PE16-008

Technical Service
Bulletins

TSB 12-12-04

TSB 14-0130

Figure 3 - Article 12-12-4

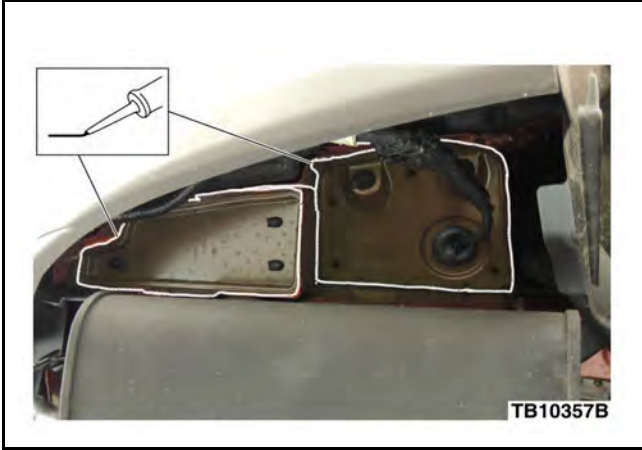
4. Raise vehicle on hoist. Refer to WSM, Section 100-02.
5. Lower and support rear section of the exhaust system.
6. Clean areas on underside of vehicle where seam sealer will be applied. (Figures 3-5)

7. Cover exhaust system and auxiliary climate control drain.
8. Apply generous amount of Motorcraft® Seam Sealer to rear horizontal sheet metal lap joints on left and right sides of the vehicle, and the rear sheet metal overlap flange across the rear of the vehicle. (Figures 3-5)

Figure 3 - Article 14-0130

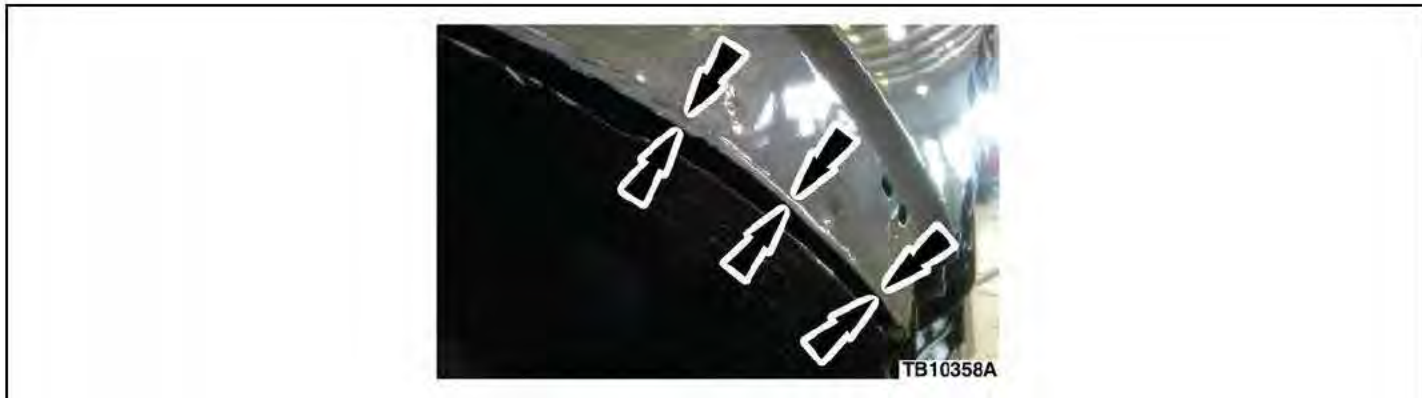
7. Raise the vehicle on hoist. Refer to WSM, Section 100-02.
8. Lower and support the rear section of the exhaust system.
9. Clean the areas on the underside of the vehicle where the seam sealer will be applied. (Figures 3-5)

10. Cover the exhaust system and auxiliary climate control drain.
11. Apply a generous amount of Motorcraft® Seam Sealer to rear horizontal sheet metal lap joints on left and right sides of the vehicle, and the rear sheet metal overlap flange across the rear of the vehicle. (Figures 3-5)
12. Spray a generous amount of 3M™ Rubberized Undercoating around the auxiliary air conditioning lines and seam sealer areas. (Figure 6)
